11 SUB2014-00005

KATHERINES PLACE SUBDIVISION

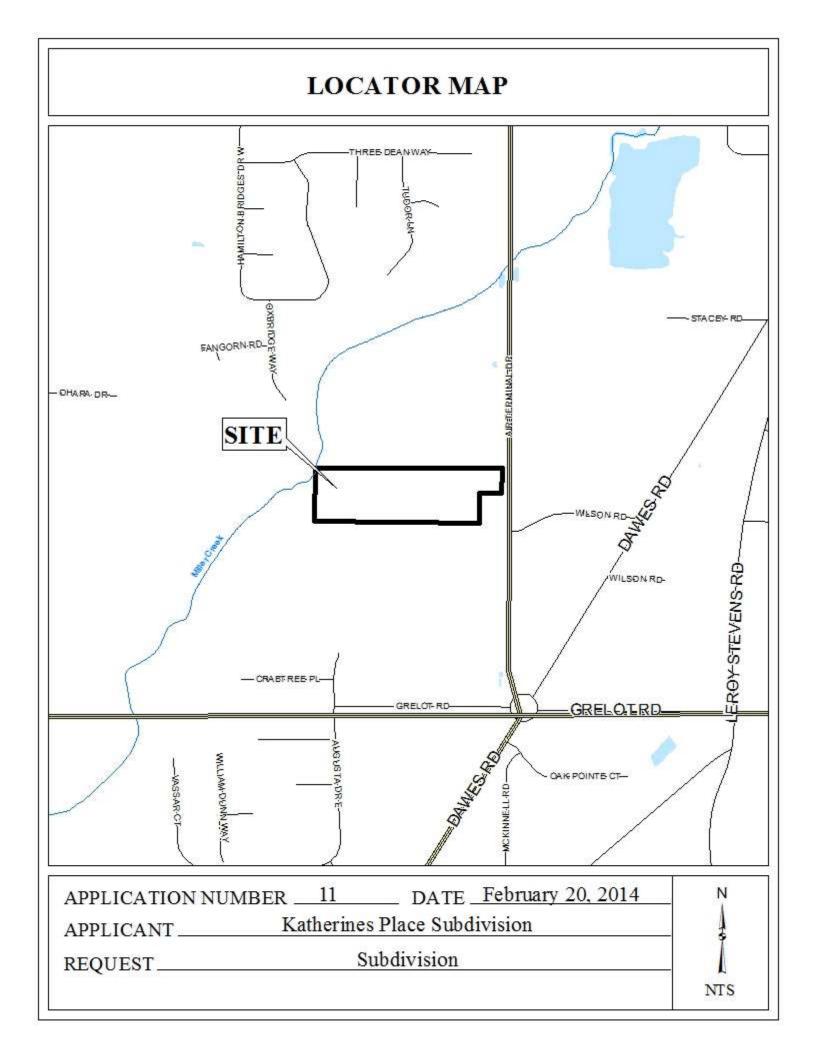
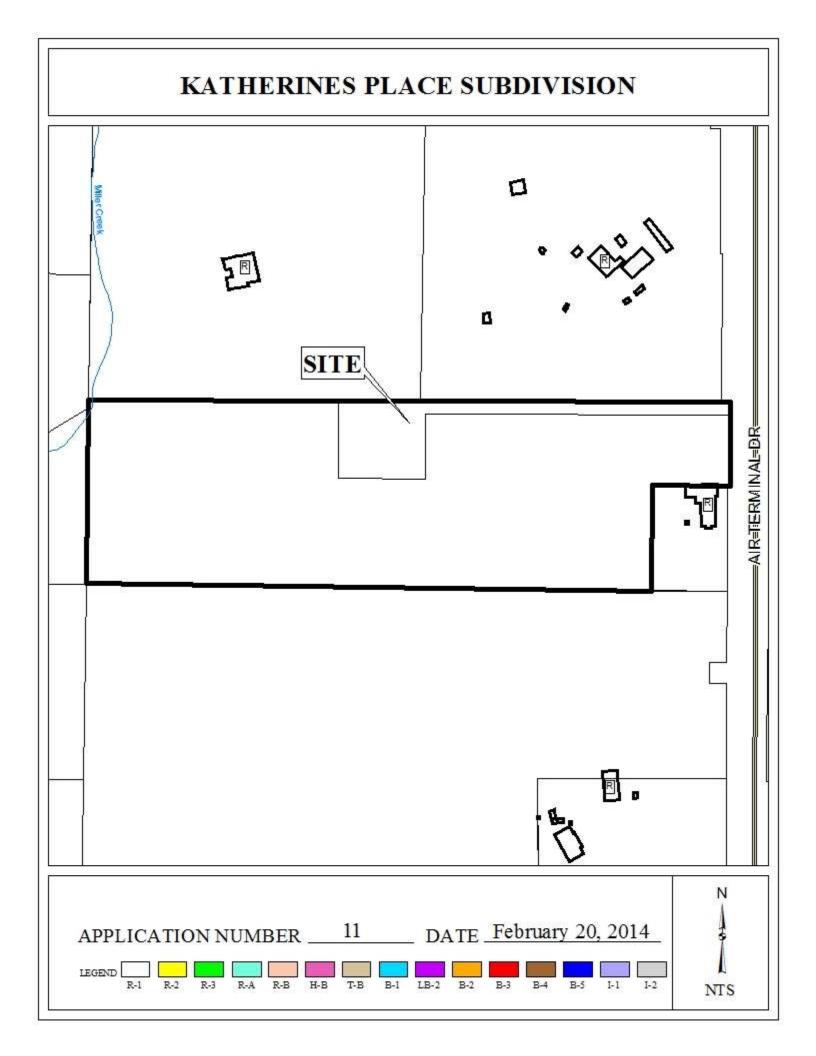
It should be pointed out that the proposed Lot 2 is irregular in shape. As proposed, the lot is over $9 \pm \text{acres}$ in size and would measure $363' \pm \text{at}$ its widest point, $1256' \pm \text{at}$ its deepest point but only provide 60' of frontage along Airport Terminal Drive. Due to the limited length of frontage, if approved, any future subdivision of the proposed Lot 2 should be prohibited until additional frontage along a public or private street is provided. This note should appear on the Final Plat if approved.

The proposed subdivision fronts Airport Terminal Drive, a planned Major Street as designated by the Major Street Plan component of the Comprehensive Plan with a right-of-way width of 100'. The existing right-of-way width is compliant thus, no dedication is required. If approved, the Final Plat should be revised to illustrate a 100' right-of-way for Airport Terminal Drive, which should also be labeled as such instead of Wilson Road.

As a means of access management, a note should be place on the Final Plat stating that both proposed lots be limited to one curb-cut each with the size, design, and location to be approved by Mobile County Engineering and conform to AASHTO standards.

GIS data indicates the presence of wetlands as well as the AE and X-Shaded Flood Zones on a portion of the site. The presence of wetlands and flood zones would indicate that the area may

be environmentally sensitive; therefore, if approved, the approval of all applicable federal, state and local environmental agencies would be required prior to the issuance of any permits or land disturbance activities. A note regarding these requirements should appear on the Final Plat if approved.

- 1) Placement of a note on the Final Plat stating that no future subdivision of Lot 2 will be allowed until additional frontage along a paved public or private street is provided;

- 2) Revision of the Final Plat to label Airport Terminal Drive with a 100' right-of-way;
- 3) Retention of the 25' minimum building setback and lot size information on the Final Plat;

- 4) Placement of a note on the Final Plat limiting both lots to one curb-cut each, with the size, design and location to be approved by Mobile County Engineering and conform to AASHTO standards;
